# Access Compliance Report

## Public Rights-of-Way

### (Curb Ramps)

Intersection ID: 32087	Main Street: JERPOINT_ABBY_DR	Cross Street: SLADE_CASTLE_CT	Location: SE
ADA ID: 3EF466DE1DA0	Ramp Type: PerpDiag	Initial Pass/Fail: Fail	Overall Compliance: No
		Severity Score: 12.5

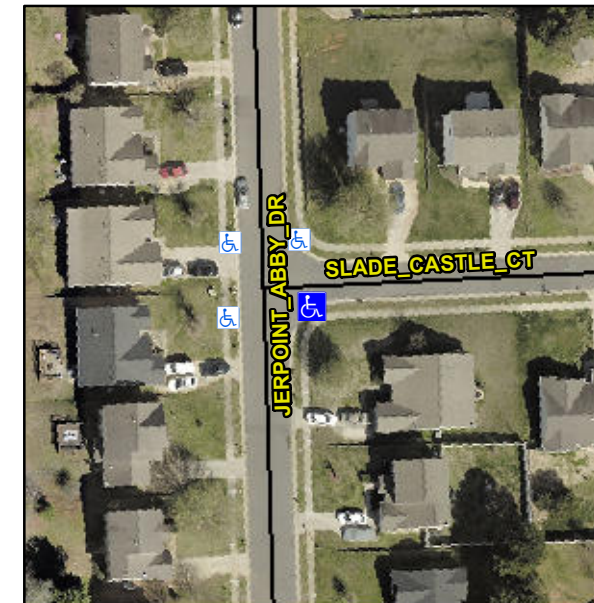
**R304.2.2**

Compliance	Description	Data	Compliance	Description	Data
N/A	Ramp Length (in)	95.0	No	Ramp Slope (%)	10.2
Yes	Ramp Width (in)	80.0	Yes	Ramp XSlope (%)	1.7
N/A	Flare Type LT	N/A	N/A	Flare Type RT	N/A
N/A	Flare Slope LT (%)	N/A	N/A	Flare Slope RT (%)	N/A
N/A	Flare Traversable LT?	N/A	N/A	Flare Traversable RT?	N/A
N/A	Landing Length (in)	N/A	N/A	DWS Provided?	N/A
N/A	Landing Width (in)	N/A	N/A	DWS Contrast?	N/A
N/A	Landing Slope (%)	N/A	N/A	DWS Length (in)	N/A
N/A	Landing X Slope (%)	N/A	N/A	DWS Full Width?	N/A
N/A	Landing Curb? (Y/N)	N/A	N/A	DWS Offset (in)	N/A
N/A	Shared Landing?	N/A			
N/A	Gutter Ponding?	N/A	N/A	Gutter Slope (%)	N/A
N/A	Gutter Lip Ht (in)	N/A	N/A	Gutter X Slope (%)	N/A
N/A	Painted X Walk1?	No	N/A	Painted X Walk2?	No
	X Walk 1 Direction	To N		X Walk 2 Direction	To W
N/A	X Walk 1 Width (in)	N/A	N/A	X Walk 2 Width (in)	N/A
	X Walk 1 Slope (%)	3.4		X Walk 2 Slope (%)	1.7
	X Walk 1 X Slope (%)	2.1		X Walk 2 X Slope (%)	6.9

**Remove & Replace Curb Ramp With Two New Directional Ramps or Equivalent.**
